## Certificate of Appropriateness

2547 N. SUMMIT AV. North Point North

**Date issued** 8/19/2020 PTS ID 115017 COA: storm door and balcony railing

South balcony showing one of the damaged posts.

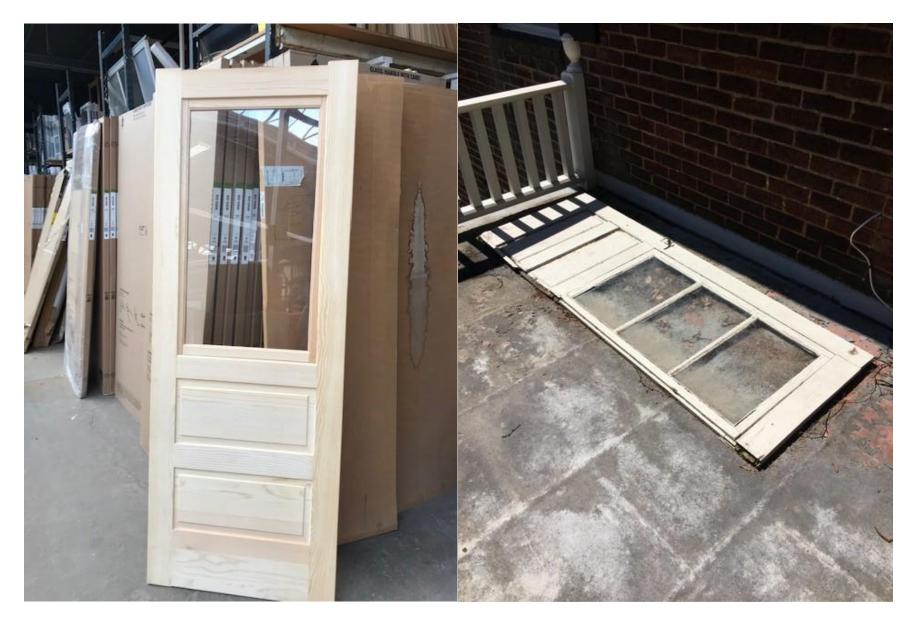
Description of work Repair and replace rotted wood on the railing of south balcony. The post needs to be replaced,

as do 2-3 balusters and the bottom rail. Balusters and bottom rail will be replaced with

identically sized cedar. Post will be replaced. Size of new cedar post will be 5.25" l by 5.25" w

by 27.75" h. Post will be primed and panted. Old post cap will be saved and reused, using

wood epoxy to repair small rotting damage and restore.

All finish wood must be smooth and free of knots and must be painted or treated with an opaque stain upon completion. Note: when new, bare wood is left exposed to the exterior elements for a period of only a week or two, the life the of the paint job subsequently applied to it will be decreased. The use of a naturally decay-resistant wood species for exterior finish applications is required for porch areas. Using western white pine or Ponderosa pine is "at your own risk" because this wood has no natural decay resistance and can deteriorate in some exterior settings in just a few years.
